**CERTIFICATE OF APPROPRIATENESS**

**RE: Application Number 20-6777; 1441 Brooklyn Street, Corktown Historic District**

Permits	
06/19/20	BZA Submission
06/18/20	Historic Commission Review
06/08/20	Owner Review
Date:	Issued For:
<b>Kaul Glove Building Renovation &amp; Adaptive Reuse</b>	
1441 Brooklyn Detroit, Michigan 48226	
<b>studiozONE : DETROIT</b>	
architectural urban interior	DESIGN
330 Madison Avenue 4th Floor Detroit, Michigan 48226	studiozonedetroit.com 313.549.2790 [p] jgb@ware-house.com

**D NORTH ELEVATION**

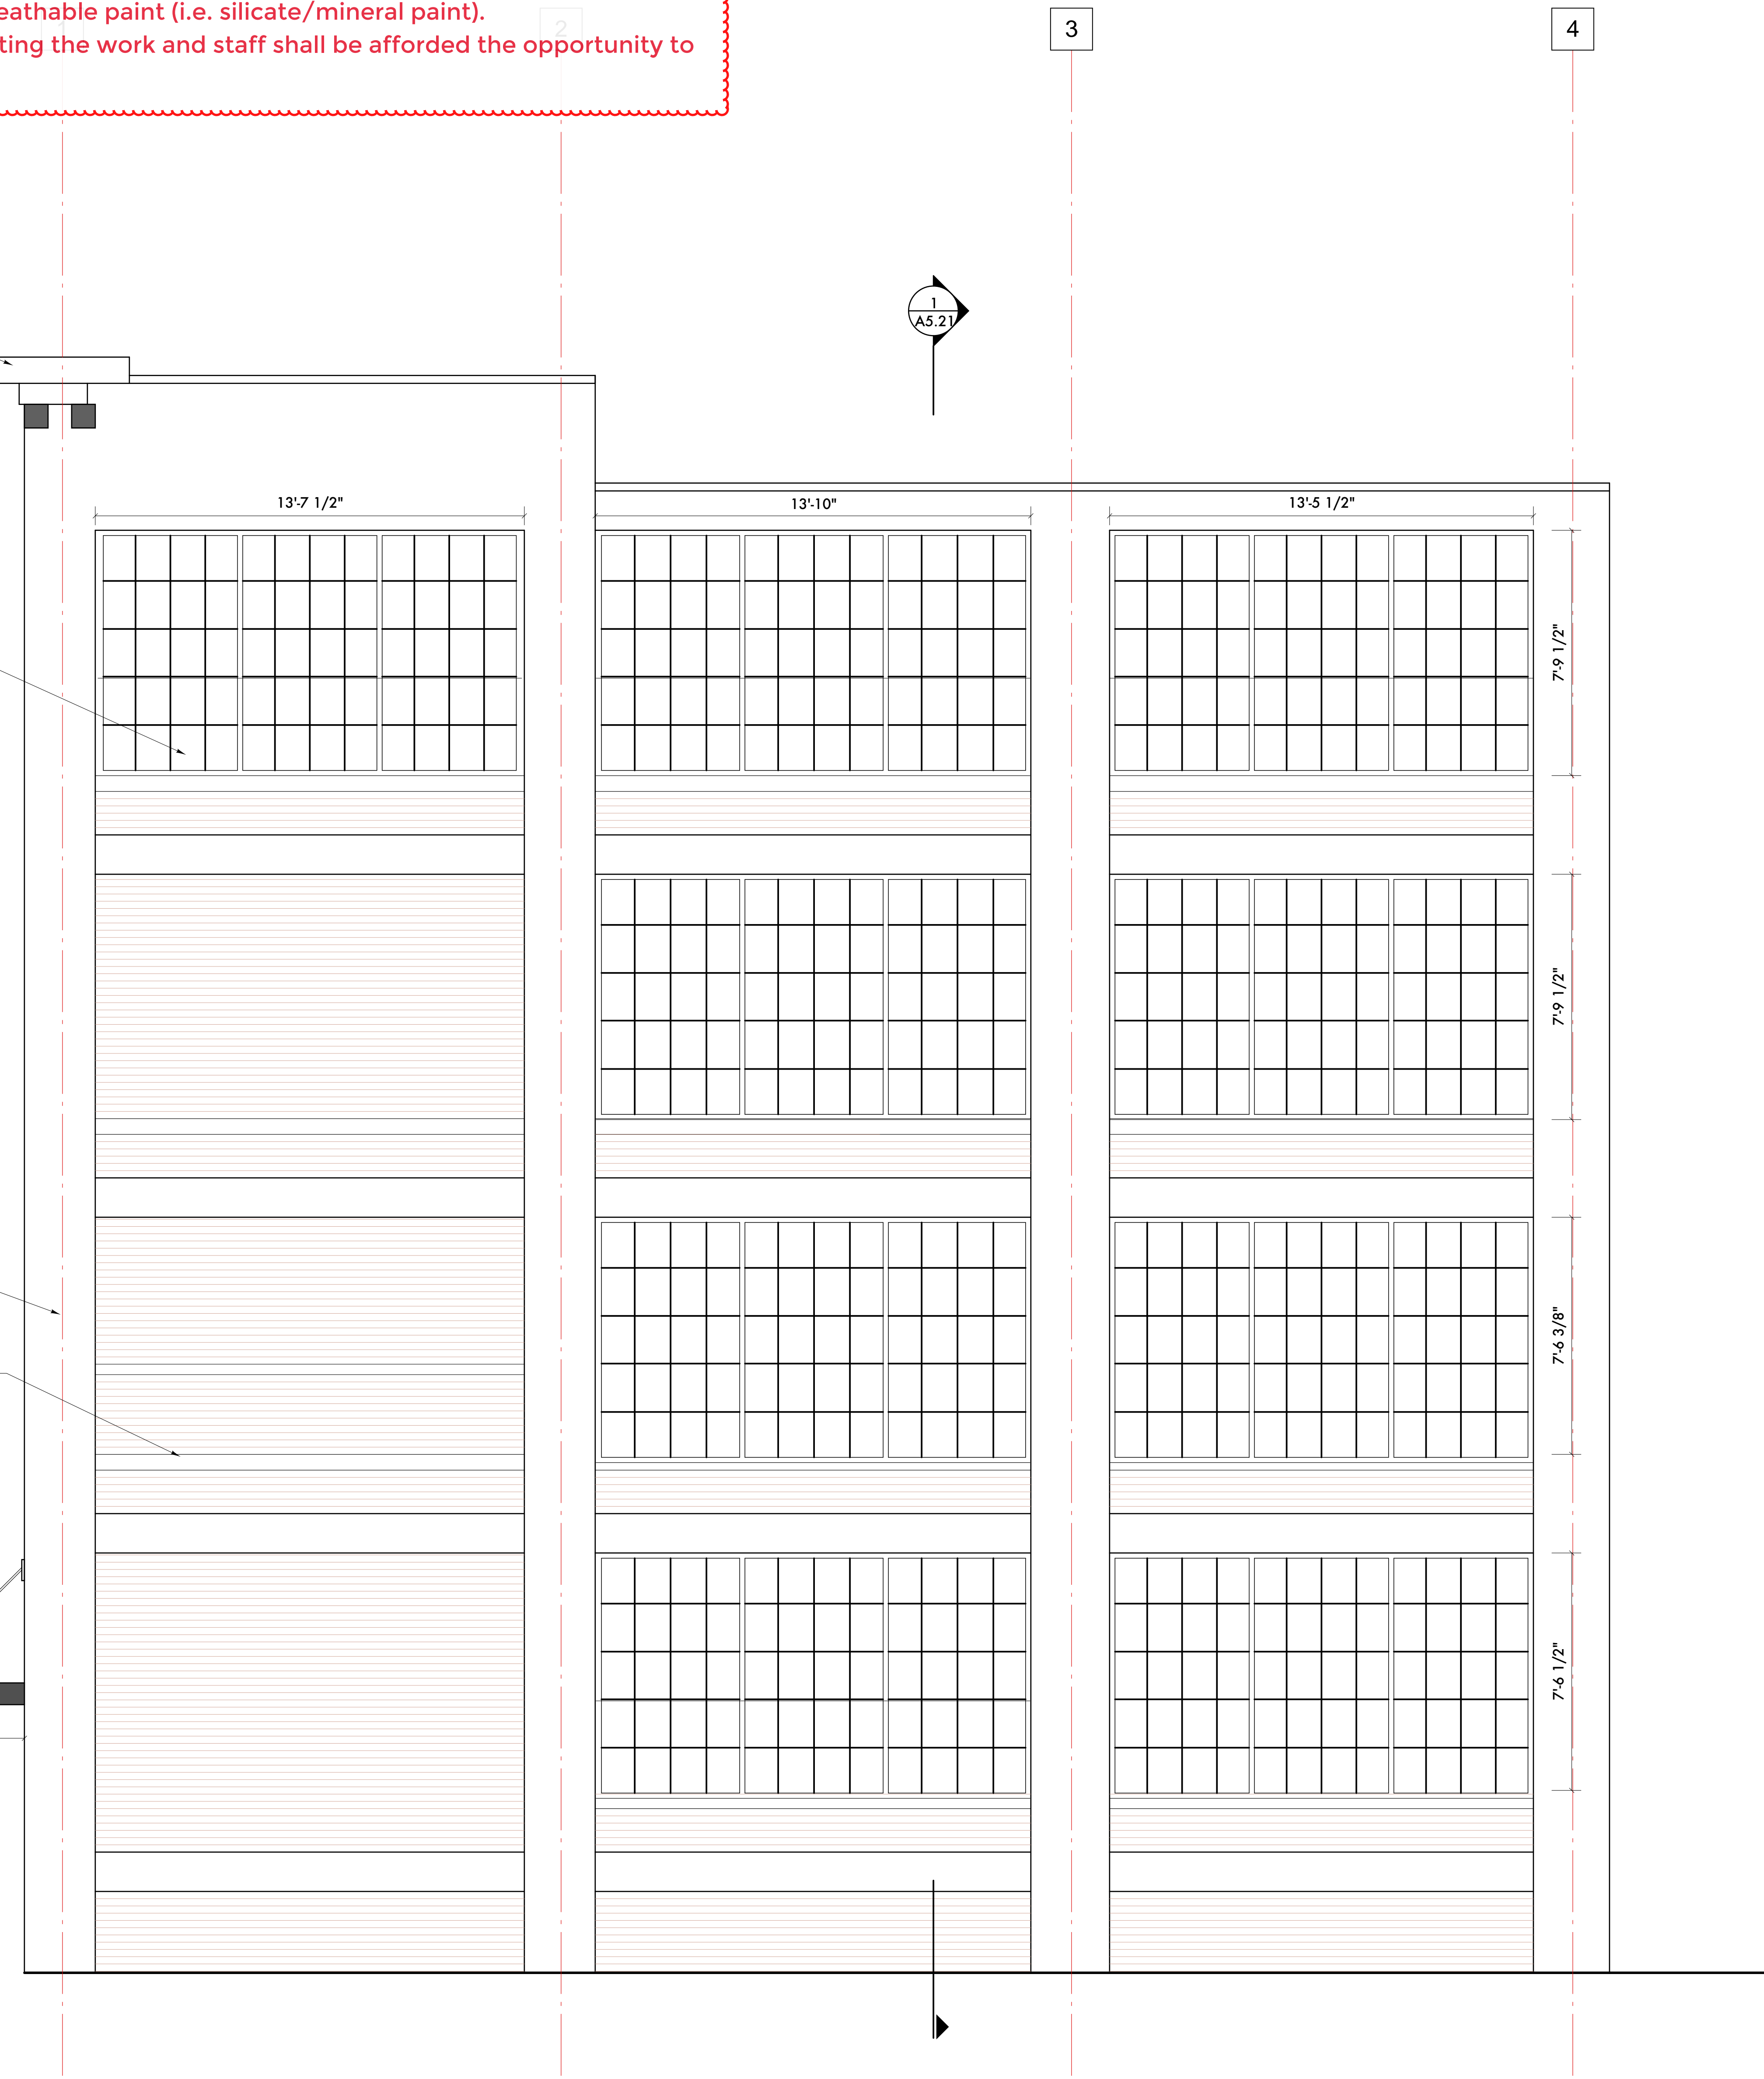
REPAIR EXISTING CORNICE  
AND REPAINT - TYPICAL

NEW ALUMINUM STOREFRONT WINDOW SYSTEM -  
BROWN ANODIZED FRAME W/ LOW-E SAFETY GLASS  
AND APPLIED MUNTINS ON INTERIOR & EXTERIOR

REPAIR EXISTING CONCRETE  
STRUCTURAL FRAME - TYPICAL

REPAIR EXISTING CONCRETE SILL - TYPICAL

**B ALLEY ELEVATION (SOUTH)**

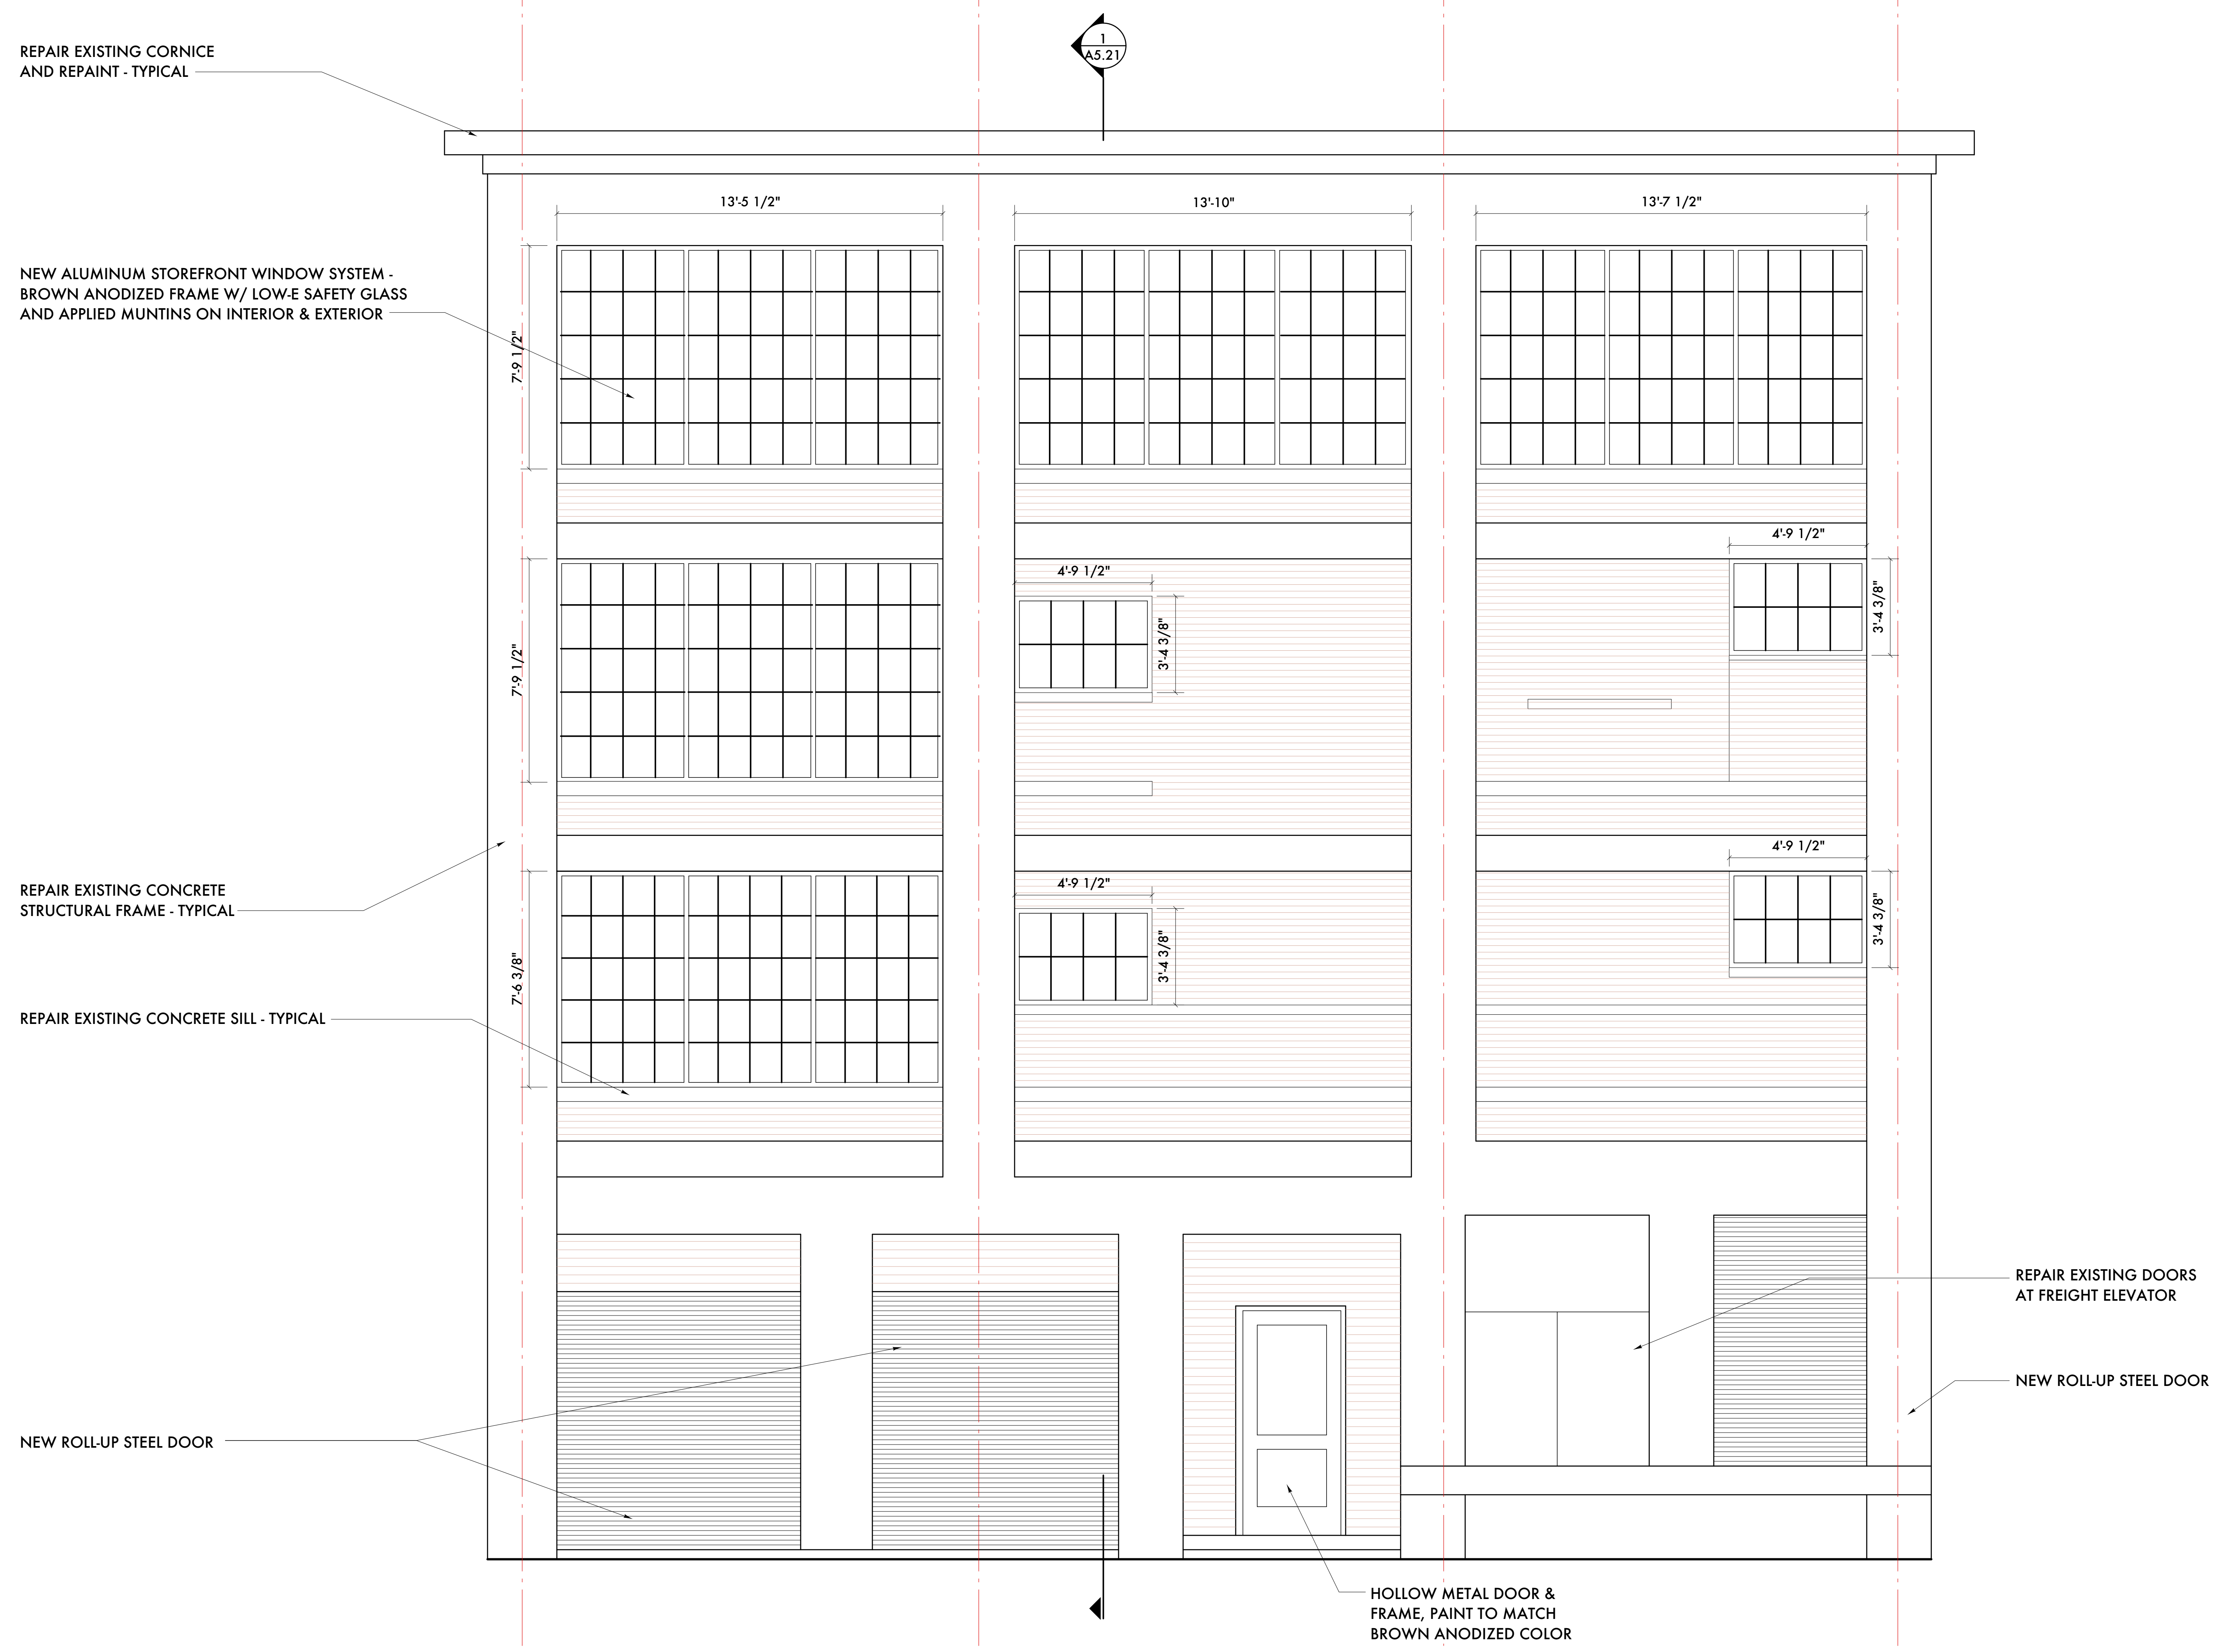
- Install (3) new roll-up steel doors at alley (south) elevation.
  - Install new hollow metal door and frame, painted to match brown anodized color of storefronts, at alley (south) elevation.

- Repair existing doors at freight elevator/loading dock at alley (south) elevation.
  - Remove existing metal canopy over loading dock at alley (south) elevation.

HOLLOW METAL DOOR & FRAME, PAINT TO MATCH BROWN ANODIZED COLOR
